# Appendix K

## **Sewer Flow Study and Memo**

Re: Lockwood 3  
CCE Project No. C20.0275D

**SUBJECT: City of Oxnard Sewer Recommendations  
Lockwood 1, 2, and 3**

SHEET  
**8A**  
 OF 49

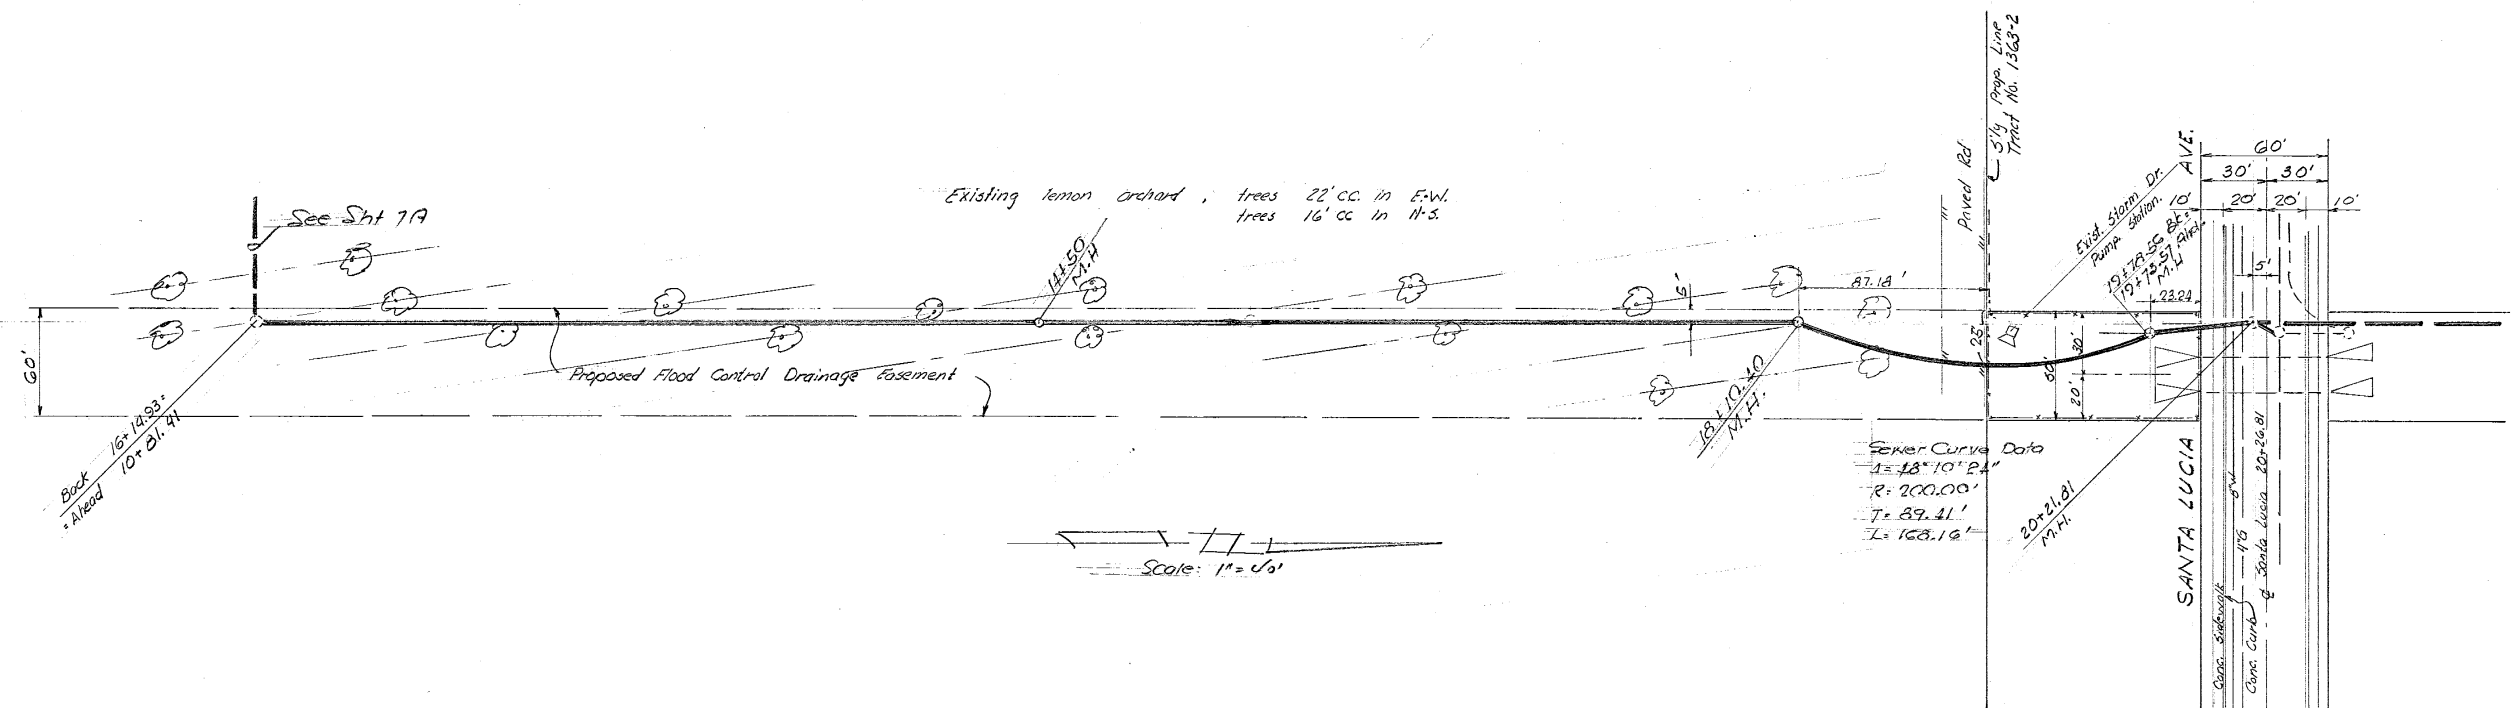
We have begun design of this sewer line and anticipate submitting these plans to the City of Oxnard by February 2, 2024. Attached to this email are as-built drawings of the existing 18" sewer line as well as the request provided by the city for monitoring of these lines. Final data will be provided once available.
